Contract #: 04-0120F4Cty: SF/ALA Rte: 80 PM: 13.2/13.9File #: 69.25B**QUALITY ASSURANCE -- NON-CONFORMANCE REPORT****Location:** Changxing Island, Shanghai, PRC**Report No:** NCR-000416**Prime Contractor:** American Bridge/Fluor Enterprises, a JV**Date:** 21-Sep-2009**Submitting Contractor:** Zhenhua Port Machinery Company, Ltd (ZPMC), Changxing Island**NCR #:** ZPMC-0390**Type of problem:**

Reference Description: Missed MT indications at East Tower, Lift 3, Diagonal Stiffener weld**Description of Non-Conformance:**

NON-CONFORMANCE REPORT TRANSMITTAL

Subject: NCR No. ZPMC-0390

项目名称 Project Name:	美国海湾大桥 SFOBB	部件图号 Drawing No.:	ESTL3-4B/K	报告编号 Report No.:	T-CWR277
合同号 Contract No.:	04-0120F4	部件名称 Item Name:	Tower(E) 3 rd lifting	NDT 报告编号 NDT Report No.:	T787-MT-5946
项目编号 Project No.:	ZP06-787

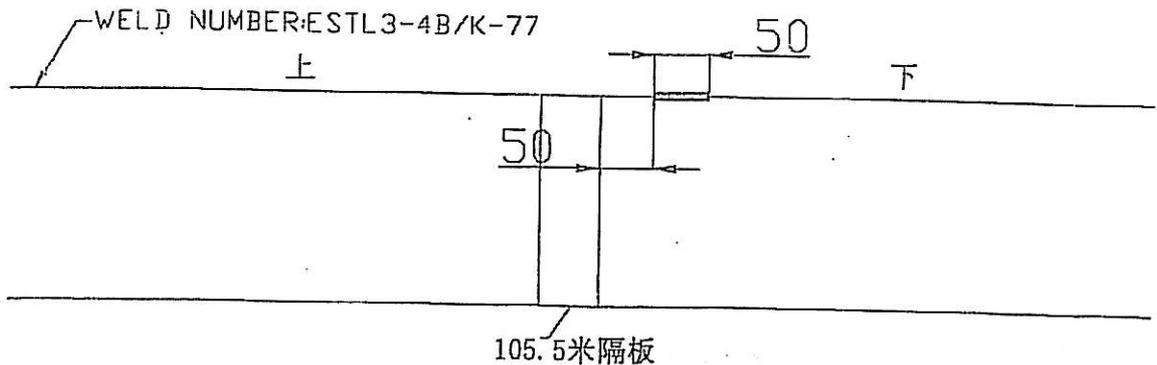
在对ESTL3-4B/K-77检测时, 发现1处纵向裂纹。L=50mm Y=50mm

One longitudinal crack was found by use of MT on ESTL3-4B/K-77.

1. QC shall monitor and direct the welder and the grinder doing the repair operation.
 2. Preheat before gouging; the temperature shall be at least 65°C.

3. Gouge the weld to remove identified defects.
 4. Joint details shall refer to the approved WPS repair.
 5. Grind the gouged areas to a smooth and shiny surface.

6. Verify with VT and MT to ensure no defects remain in the weld joint prior to welding.
 7. QC shall monitor all welding passes being deposited.
 8. QC shall ensure all slag has been removed prior the deposition of next pass.

9. Preheat and maintain interpass temperature control in accordance with the WPS.
 10. Blend the weld repaired areas into the adjacent weld or base metal by grinding.

11. Perform VT, MT and UT NDT inspection to the repaired areas.
1. 在返修过程中, QC 应该监控和指导焊工和打磨工;
 2. 碳刨之前必须先进行预热, 温度不低于 65° C;
 3. 碳刨去除缺陷;
 4. 缺陷被完全消除后, 必须准备一个正确的接头型式, 具体接头型式请参见对应的修补焊接工艺规程(WPS);

项目名称 Project Name	美国海湾大桥 SFOBB	部件图号 Drawing No	ESTL3-4B/K-78	报告编号 Report No.	T-WR2728
合同号 Contract No.:	04-0120F4	部件名称 Items Name	东塔第三吊装段 The 3 rd lifting Tower(E)	NDT报告编号 Report No.of NDT	NA
项目编号 Project No.:	ZP06-787

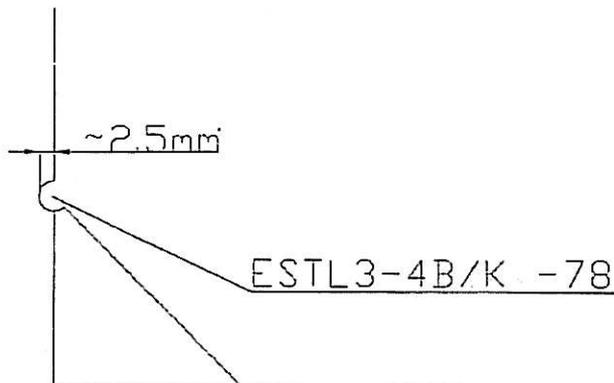
东塔第三吊装段斜筋板与面板焊缝(ESTL3-4B/K-78)发现一处咬边, 深度约为2.5MM, 如图:
The undercut was found at third lifting diagonal stiffener and skin (ESTL3-4B/K-78), 2.5mm in length, see draft.

烧焊时焊接电流偏大, 导致产生咬边.

Welding current too fast caused the undercut.

- 1、Grind the building-up area;
 - 2、Preheat and weld passes temperature according to the approved WPS, it should be 2-3mm than the theory size;
 - 3、Grind the weld area smoothly after repairing;
 - 4、Perform 100%MT and 100%UT to the repair area.
-
- 1、对需堆焊部分进行打磨;
 - 2、按批准后焊接工艺规程 WPS 要求进行预热和控制道间温度, 进行堆焊, 略高于理论值 2~3mm;
 - 3、施焊完毕后将施焊位置打磨平整;
 - 4、对修补区域做 100%MT+100%UT.
